Town of Kittery Maine
Town Planning Board Meeting
July 14, 2016

17 Island Ave – Shoreland Development Plan Review

Action: Hold a public hearing; Approve or deny plan. Owner/applicant Shelley Wieler requests consideration of plans to demolish and reconstruct, in an expanded footprint, an existing single-family dwelling, located within the 100-foot setback from a protected water body. The site is located at 17 Island Ave (Tax Map 1 Lot 8) in the Residential-Urban (R-U) and Shoreland Overlay (SH-OZ-250') Zones. Agent is Doug Greene, Port City Designs

Proposed Floor Plan

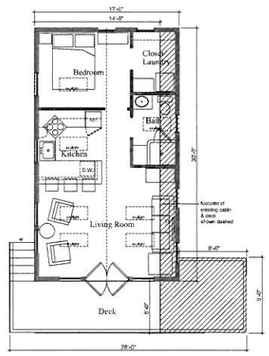
a. *The existing gross floor area submitted by the applicant is 559 square feet. The proposed floor area is 708 square feet. This is an increase of 26.7%.* **UPDATE:** The existing floor area is 559 s.f. The applicant has submitted revised proposed floor plans depicting a proposed floor area of 703 s.f. This is an increase of 25.8%.

i. The plan incorrectly depicts this increase as 17% due to a typo in the calculation, (703-599 should be revised to 703-559).
    b. *The existing gross volume submitted by the applicant is 3,913 cubic feet. The proposed volume is 5,067 cubic feet. This is an increase of 29.5%.* **UPDATE:** The existing volume is 3,913 c.f. The applicant has submitted revised proposed elevation plans depicting a proposed volume of 5,760 c.f. This is an increase of

j. Revise proposed floor area calculations and percentile.
    k. The final plan must depict a proposed development in which the expansion does not result in an increase to the structure's volume that is 30% or greater.

Site Plan Sketch

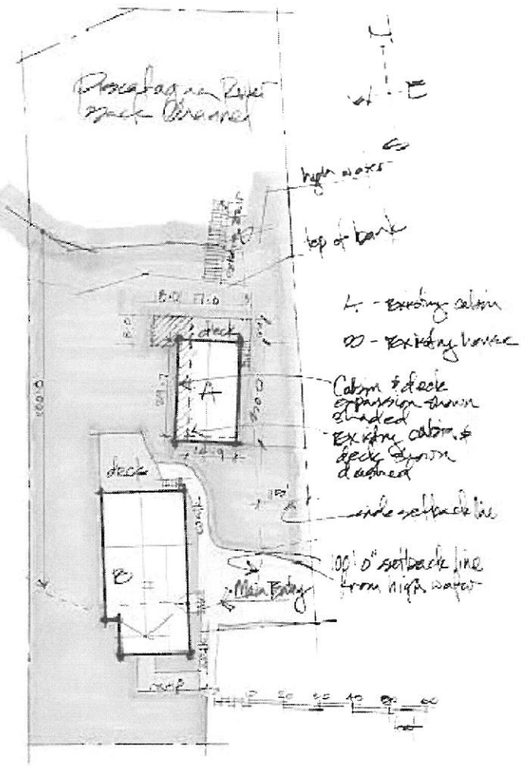
1. *The plan does not depict the location of the 100-foot setback boundary line. Staff estimates the 100-foot setback line is approximately the middle of the principal dwelling, depicted as house B on the Shoreland Development Plan (Sheet A1, prepared 5/16/2016).* **UPDATE:** The applicant will submit an updated standard boundary survey that depicts existing conditions, as well as all setbacks. Setbacks are not marked on the Site Plan Sketch included with the Shoreland Development Plan.

8. *The side setback is 15-feet in the Residential-Urban Zone. Side setbacks are not depicted on the submitted boundary survey or sketch site plan, however it appears the existing deck may encroach on the Easterly side setback. The proposed development, as drawn, creates a greater encroachment on this setback. The applicant must revise plans to depict an expansion that does not increase non-conformity by limiting any side setback encroachment to be no further than what already exists.* **UPDATE:** The applicant has revised the plans and moved the proposed expansion to the westerly side of the existing structure, away from the side setback. The proposed development does not create a greater encroachment than is currently existing.

e. Include all front and side property setbacks, as well as the 100-foot setback as measured from the Highest Annual Tide line on the site plan sketch.
    ~~f. Remove any development that encroaches in the side setback further than what is existing~~

Locus Map

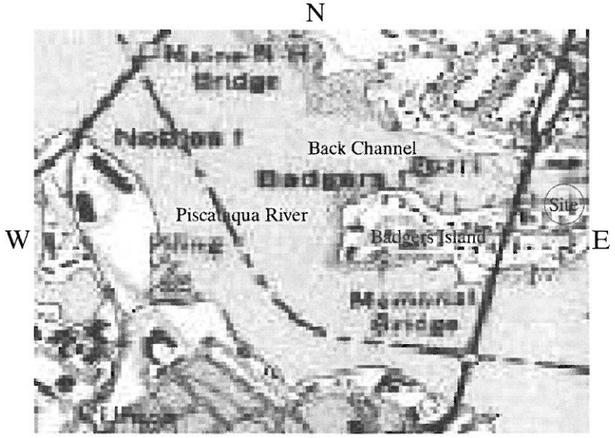
9. The locus map, as depicted on the Shoreland Development Plan, is difficult to read. The perspective should be modified so it depicts a clearer image of the site location in relation to its surroundings.

i. Include Locus Map to show property in relation to surrounding roads, within two thousand feet of any property line of the development The applicant has addressed this comment, however the map should be revised for clarity.

Shoreland Development Plan
Map 1 - Lot 8

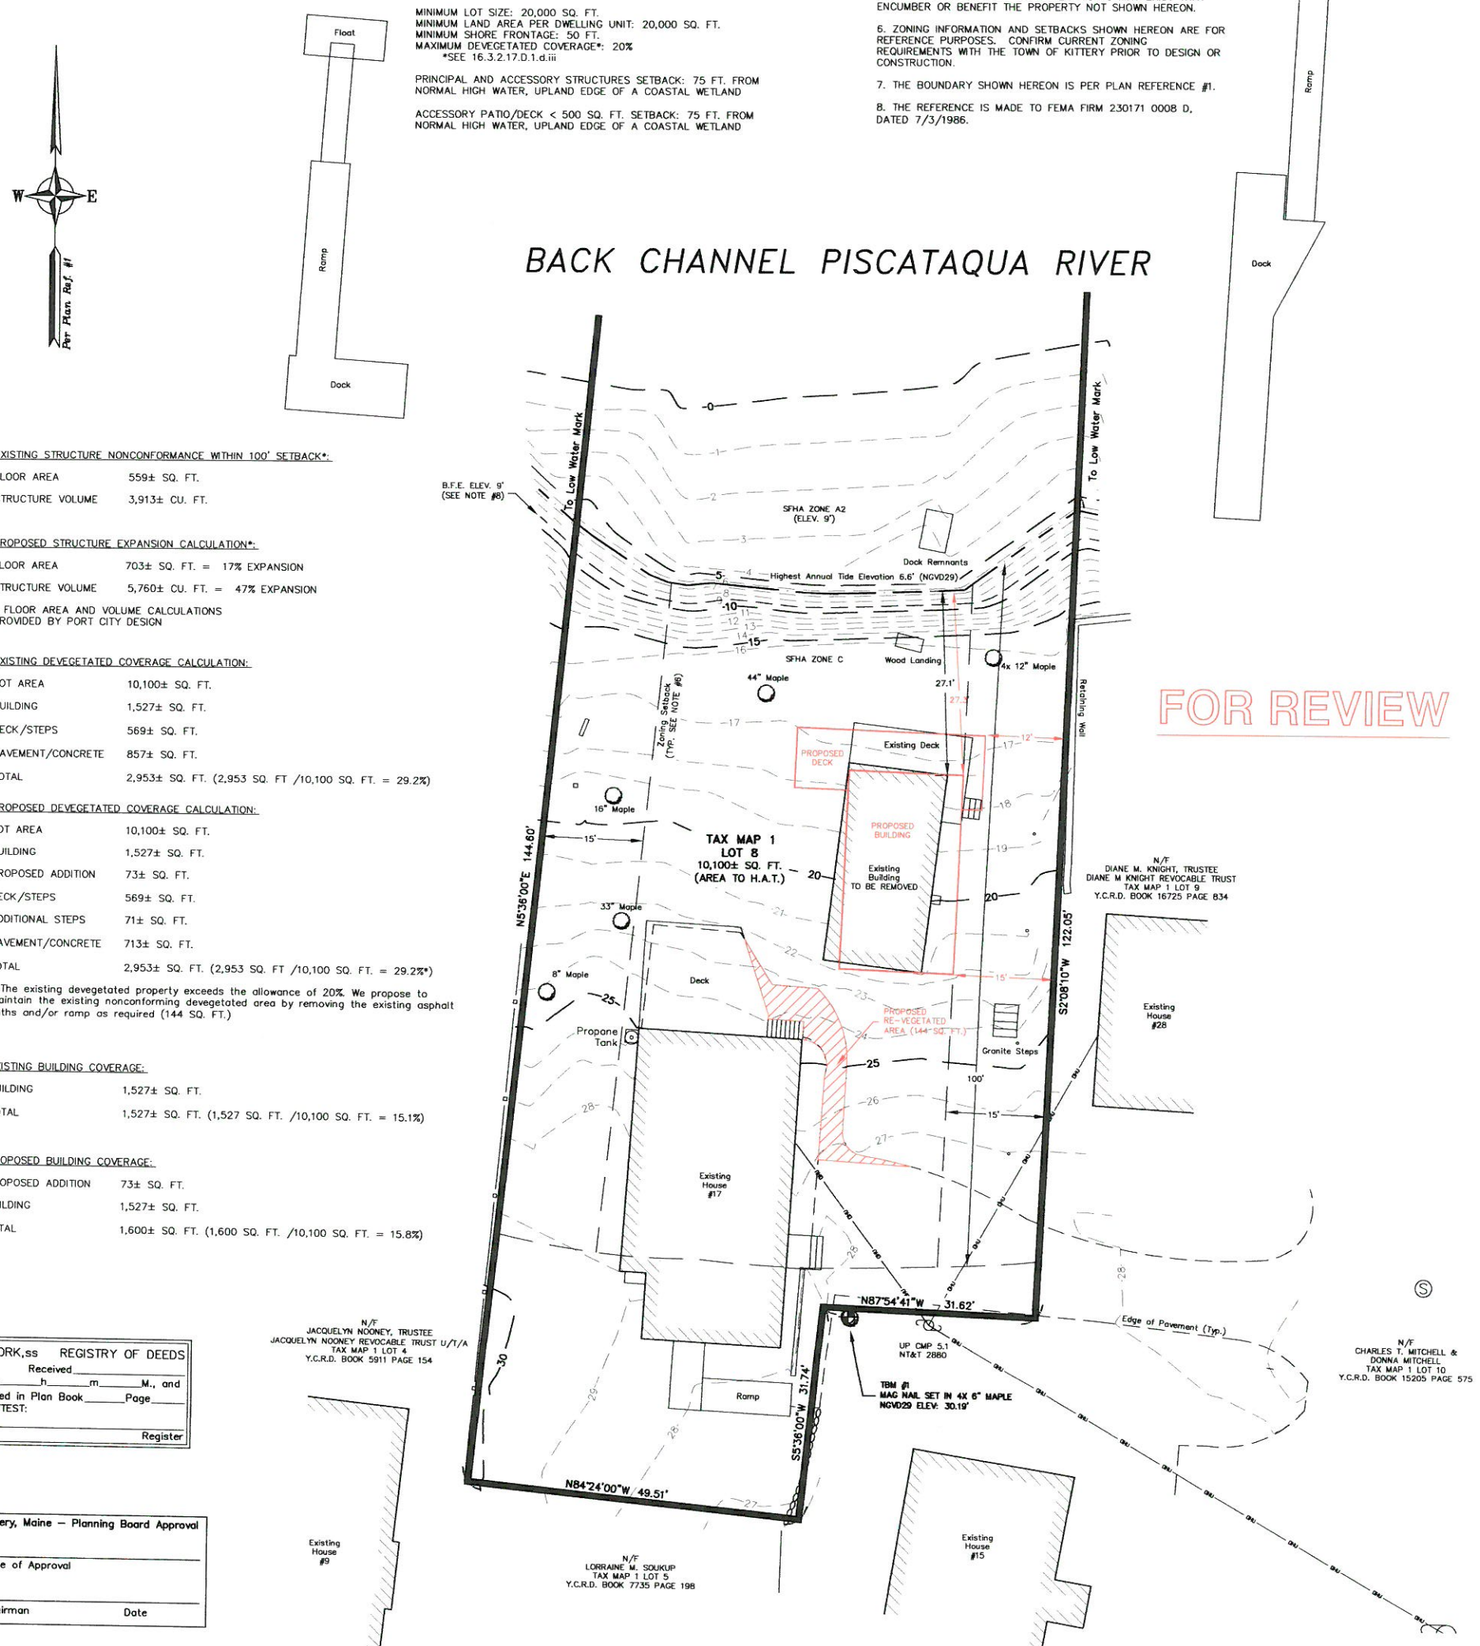
47% and is not within the 30% lifetime expansion limit. To comply with the 30% limit, the proposed development cannot result in a volume greater than approximately 5,086 c.f. Volume of a structure is defined as "the volume of all portions of a structure enclosed by room and fixed exterior walls, as measured by the exterior faces of these walls and roof."

a. The existing floor area is 559 square feet. The proposed floor area is 703 square feet. This is an increase of 25.8% and conforms to this standard.
b. *The existing volume is 3,913 cubic feet. The proposed volume is 5,760 cubic feet. This is an increase of 47% and **does not** conform to this standard.*

9. Is in conformance with the provisions of this code; Finding: The proposed development complies with the applicable standards of Title 16, *with the exception of 16.7.3.6.1.A. The proposed volume increase must be less than 30%* Conclusion: *This requirement does not appear to be met.*
Vote: ___ in favor ___ against ___ abstaining
10. Be recorded with the York county Registry of Deeds. Finding: With consideration of condition # 5, a plan suitable for recording has been prepared. Conclusion: As stated in the Notices to Applicant contained herein, shoreland Development plans must be recorded with the York County Registry of Deeds prior to the issuance of a building permit.
Vote: ___ in favor ___ against ___ abstaining
